PINS Reference EN010137 Mona Offshore Wind Farm
Affected Party Numbers MNOW-S57019 & MNOW-S57018

CLOSING STATEMENT

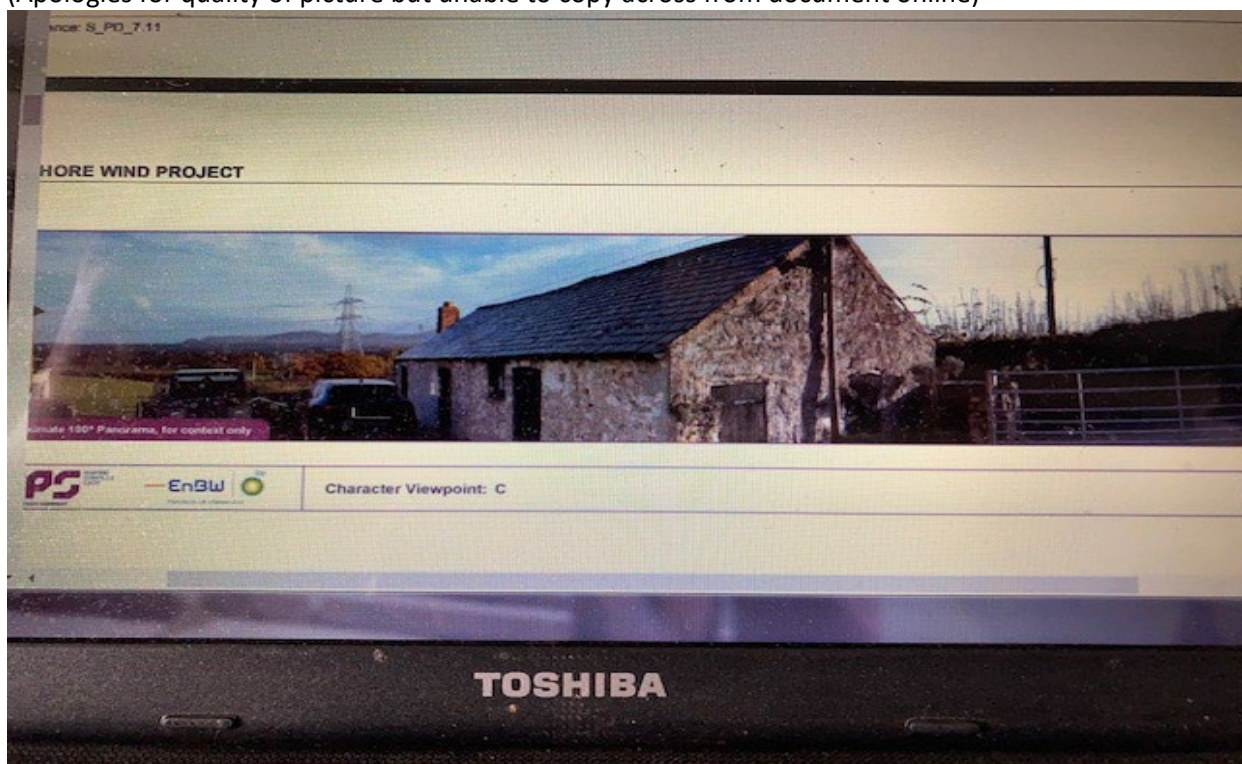
Although we have raised on a number of occasions that the photographs taken from our property do not provide a true, accurate and honest evaluation of the reality in relation to the visual impacts from this development, the applicant has and continues to maintain that the photographs taken from our property do present an accurate representation of the views from that location. This we simply cannot and do not accept as they present a very much biased and selective view and in no way show the real views from our principal ground floor living space or any of the areas of our North Eastern Curtilage.

Below is the photograph that the applicant insists is representative, taken from our South west corner, deliberately showing one of our outbuildings. For those who visited our property during the site visit (examiners and applicant representatives) know that this is not a true representation.
